PRELIMINARY SITE SKETCH
SONIC DRIVE-IN
SHREVEPORT, LA
PIERREMONT & THORNHILL
DRIVE-IN STALLS: 20
NON STALL PARKS: 14

05-20-2019
PROJECT: #5253 RELO
LAYOUT: 18+
DESIGNER: DR
OWNER: D.L. ROGERS

19-347-C

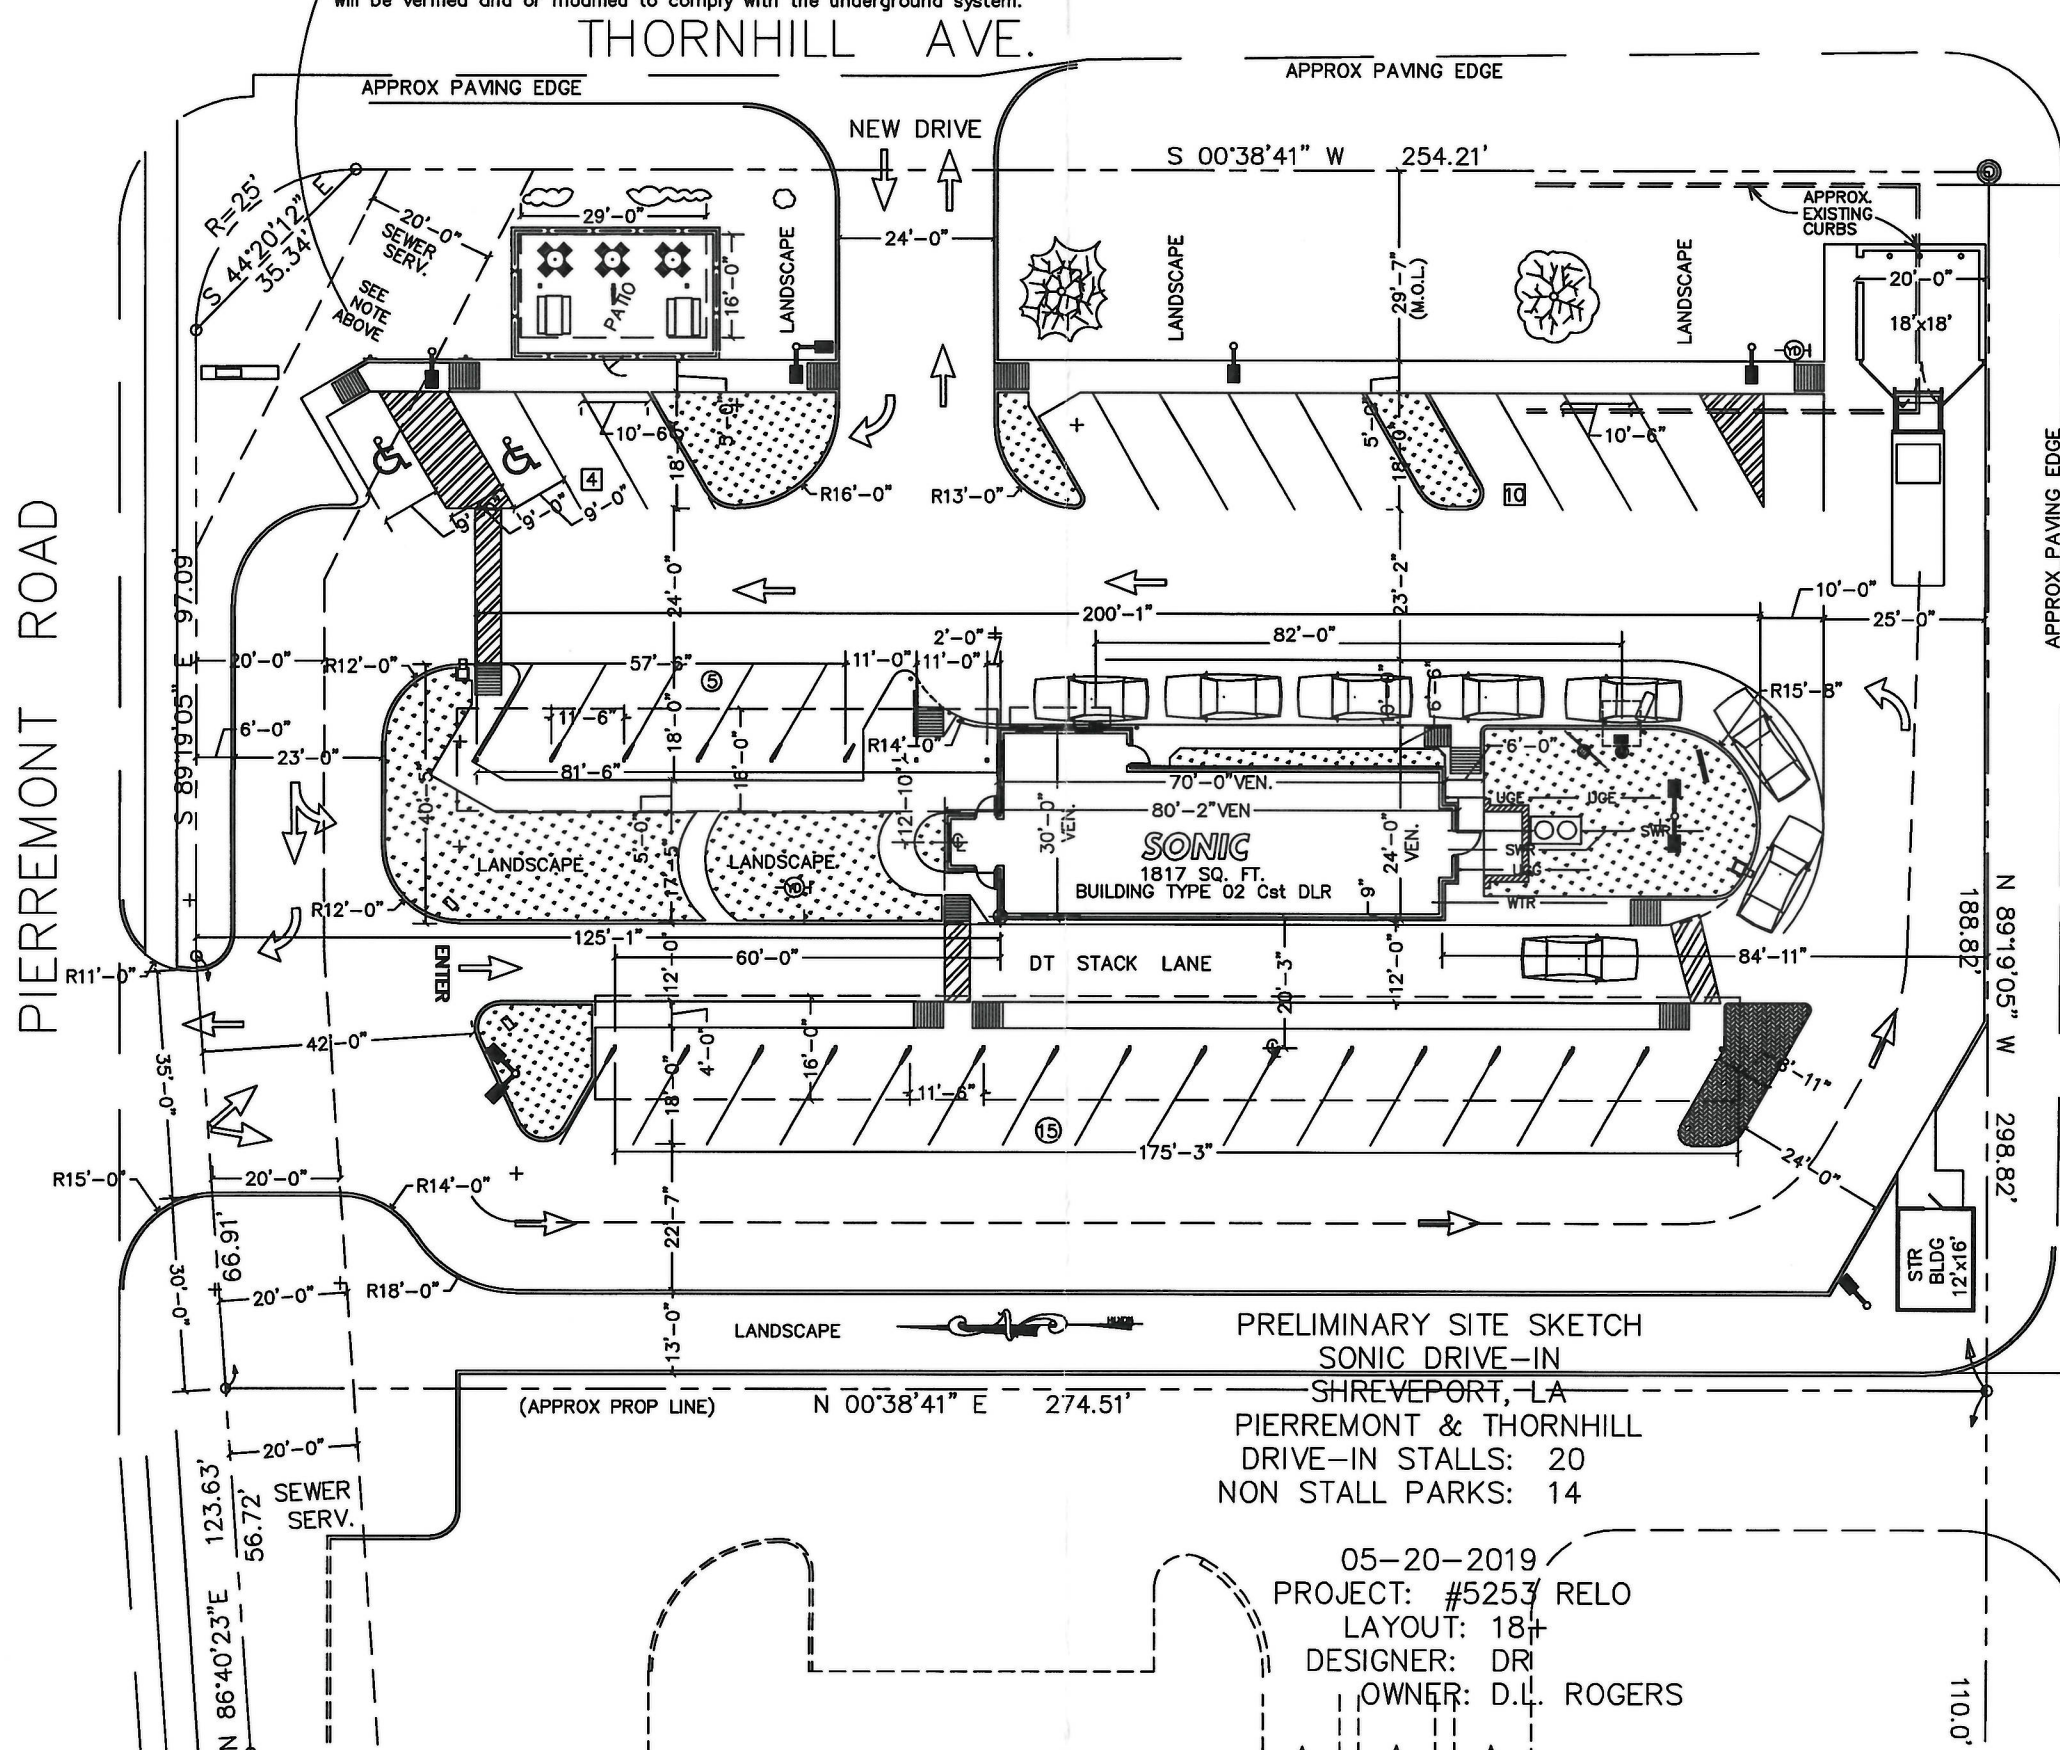
"Drainage improvements, as it applies to detention, will be designed as an underground system to satisfy the City of Shreveport's detention ordinance. Hydrologic and hydraulic calculations set forth in Mohr and Associates drainage report dated April 2018 will be verified and or modified to comply with the underground system."

MPC Note: Existing Fence along Mitchell Lane to Remain
